Town of Medway
DESIGN REVIEW COMMITTEE
155 Village Street, Medway MA 02053
(508) 533-3291

DRC Meeting Minutes: December 16, 2019
Medway Public Library

FRONT ELEVATION - TRIPLEX
SCALE: 3/4" = 1'-0"

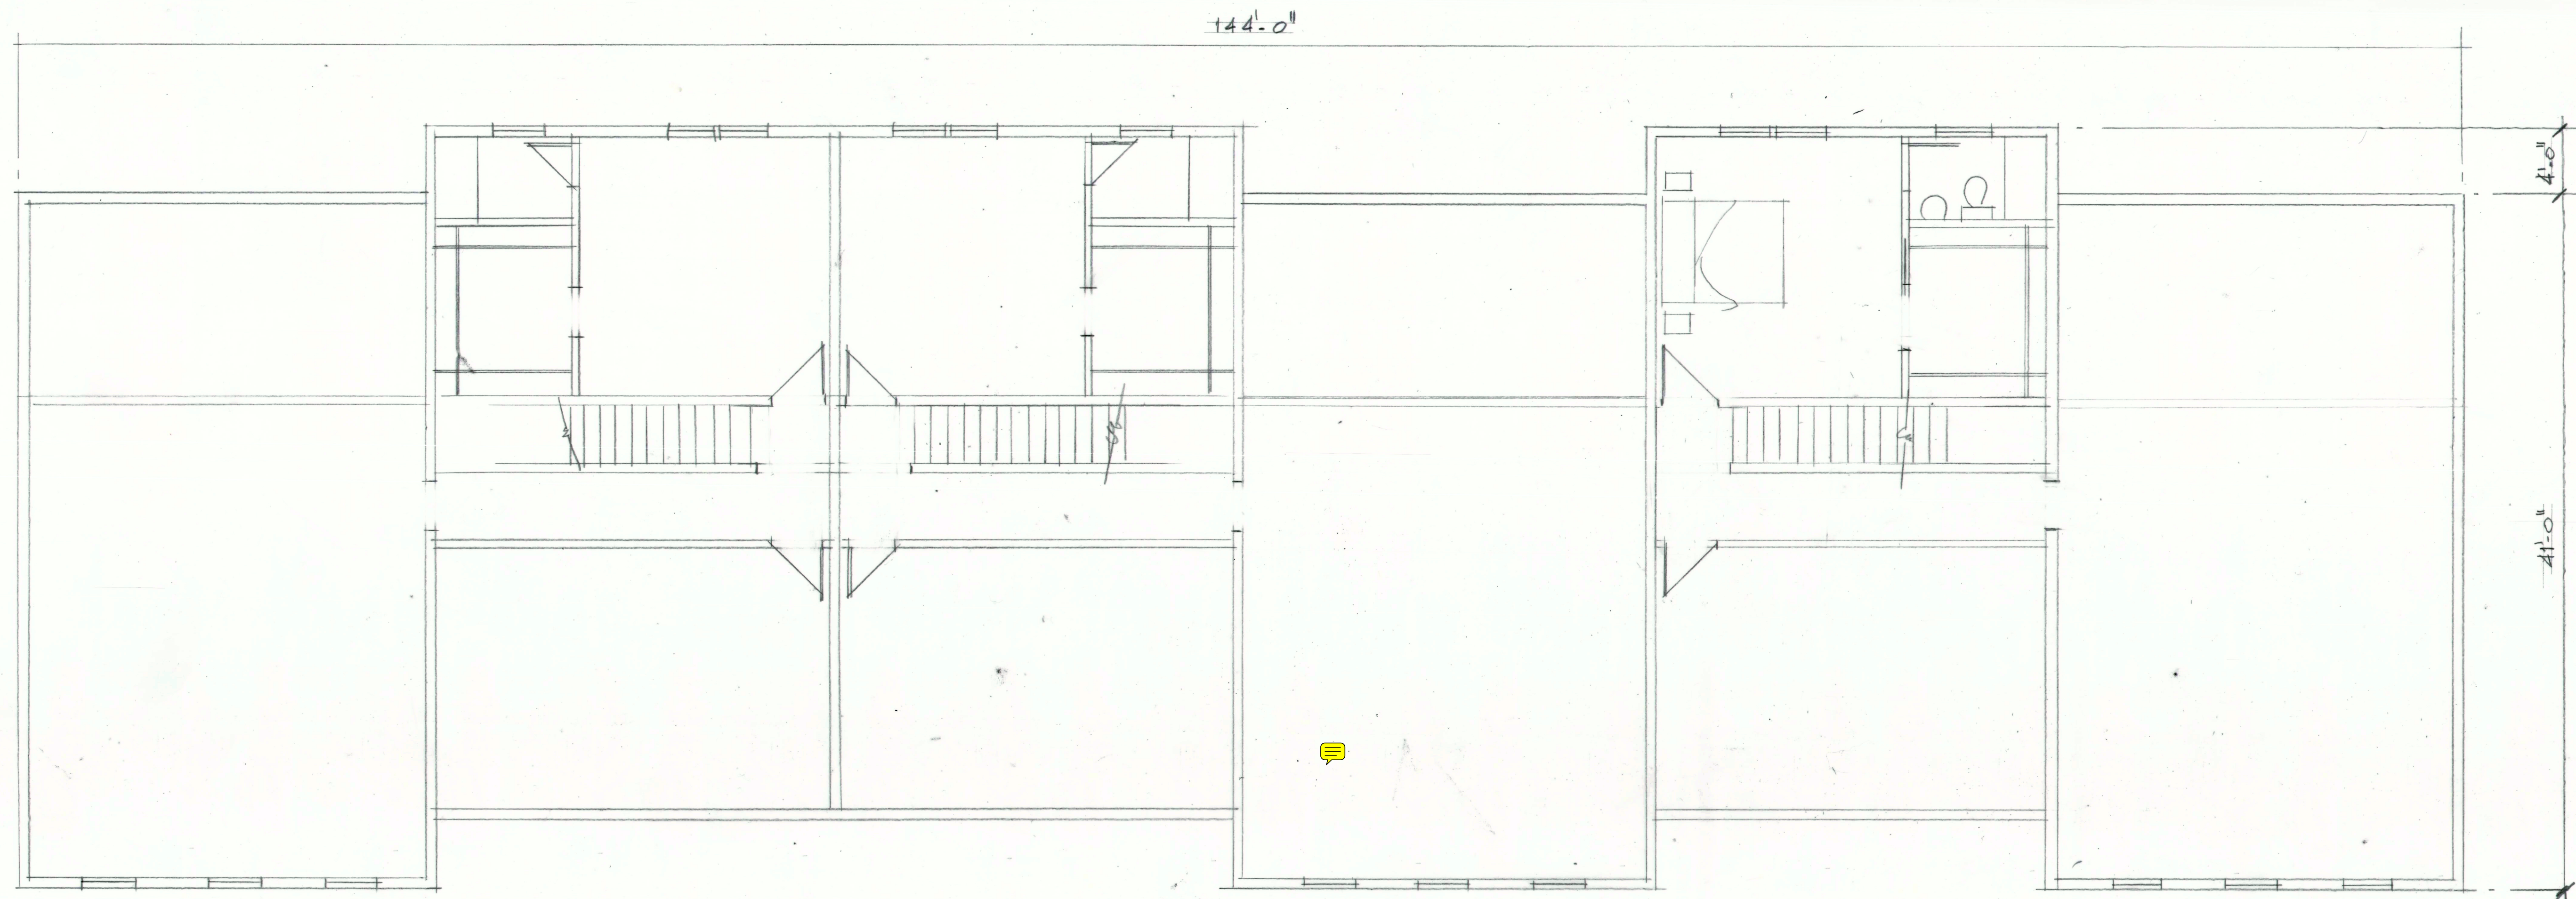
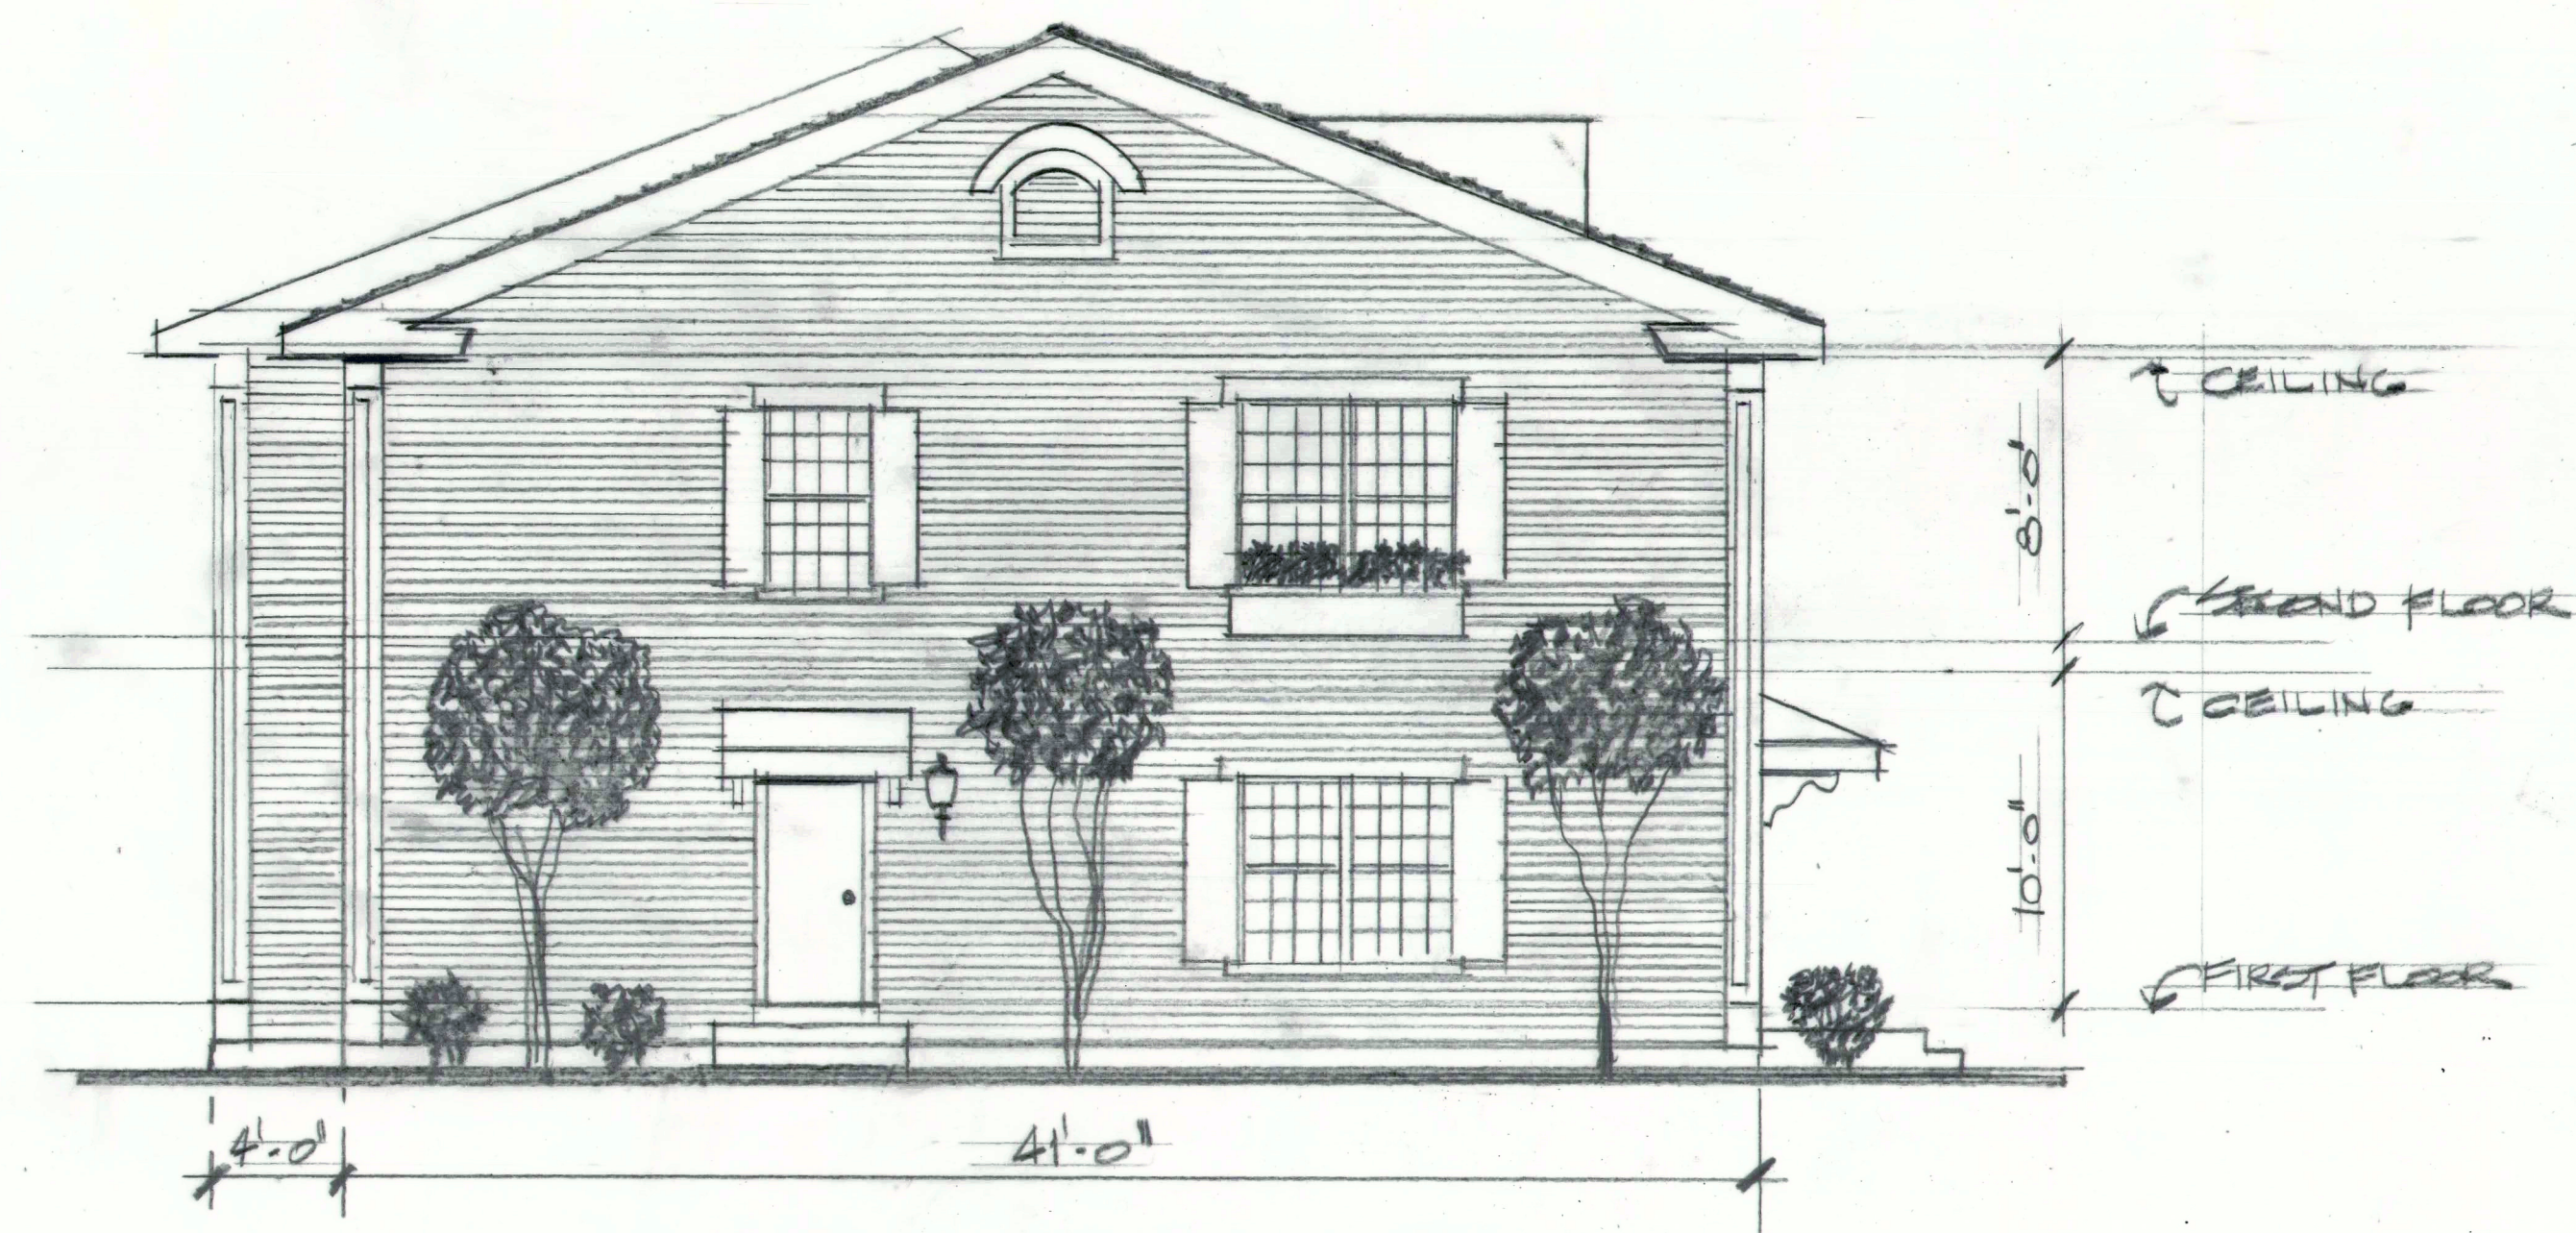
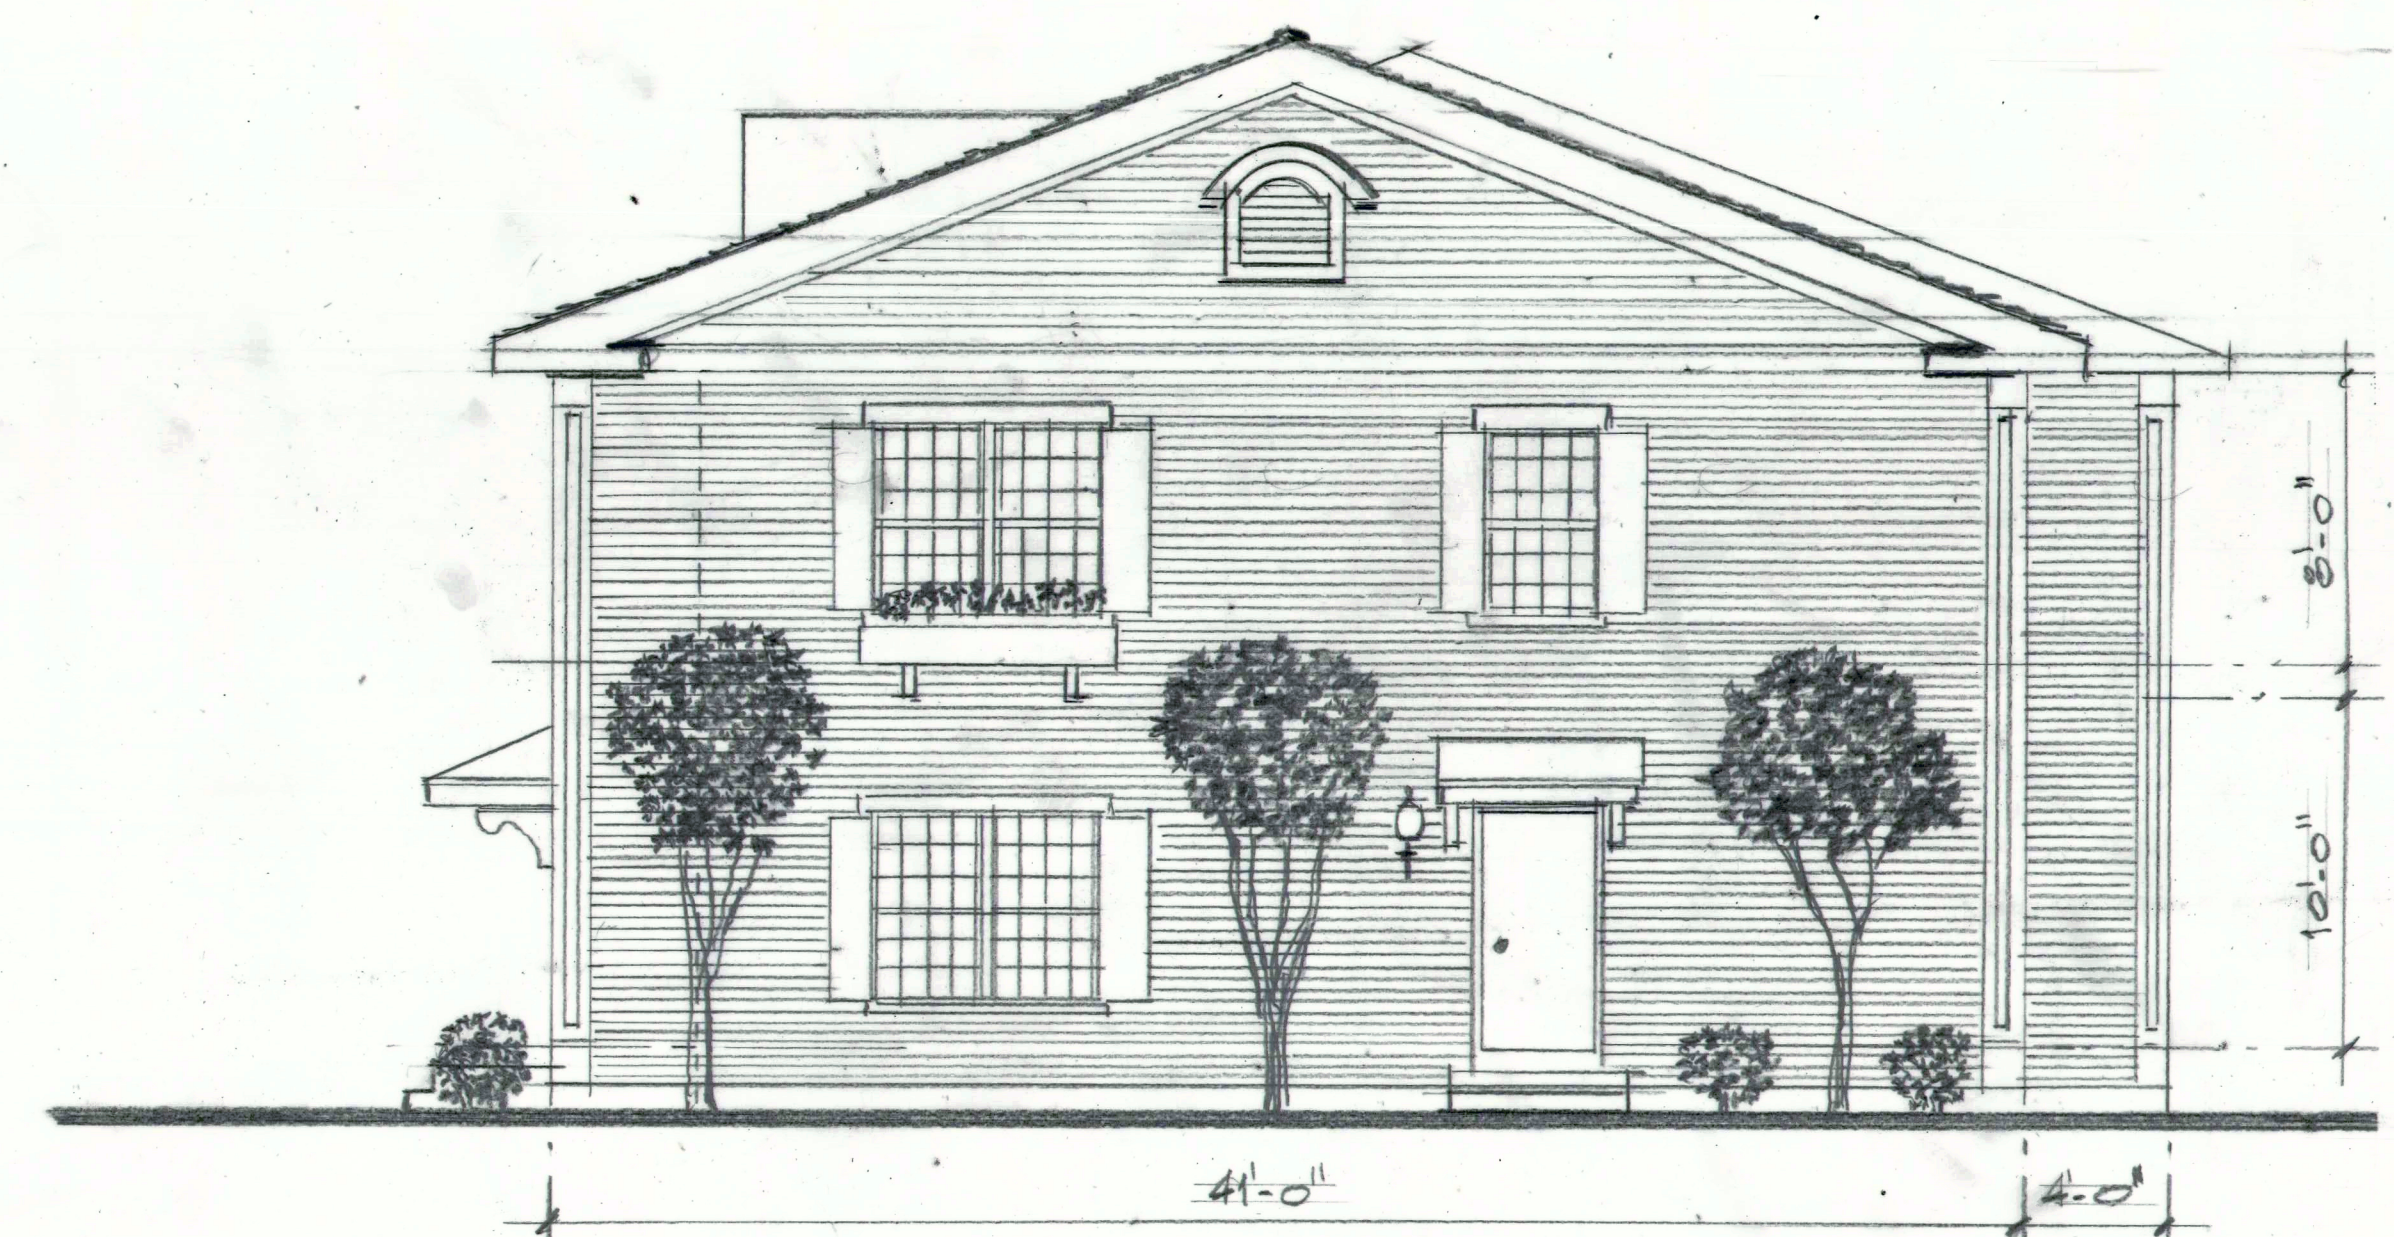
- The submitted rendering **(See Attached)** showed 4 duplex units in front and one triplex building. Members liked the revised building elevations as presented. There will be a granite wall along the front of the site at Village Street. A sign will hang off of the granite posts. Reclaimed granite will be set in the ground with 12" of exposure. A 4"x8" cap will run across the length of the wall.
- There are no trees around the 1st unit but trees will be included between the 2nd and 3rd buildings, and the trees on the rest of the property will be saved. Mr. Rucki requested

- Scottish thistle color was favored for building #1, silver gray for building #2, pebble stone clay for building #3, and white for the fourth building. White will be used for existing structure and the triplex building will use one of the noted three duplex colors with all three units being the same color.

Hi Susan I just sent over the revised triple .We had worked over the weekend reviewing the other duplexes with various styles .We were unable to make various changes that would be acceptable to us and to the DRC. The Architect suggested that I was trying to put too many styles of homes for a small development and suggested that we use the row house style for the first 3 duplexes and the triple. We are able to maintain consistency in style but we are able to move each section of the duplex to eliminate the massing which has been a major concern. Using various colors on siding and door will help with this as well. We will have the duplex rendering and plan view of layout on Monday. Have a nice few days off
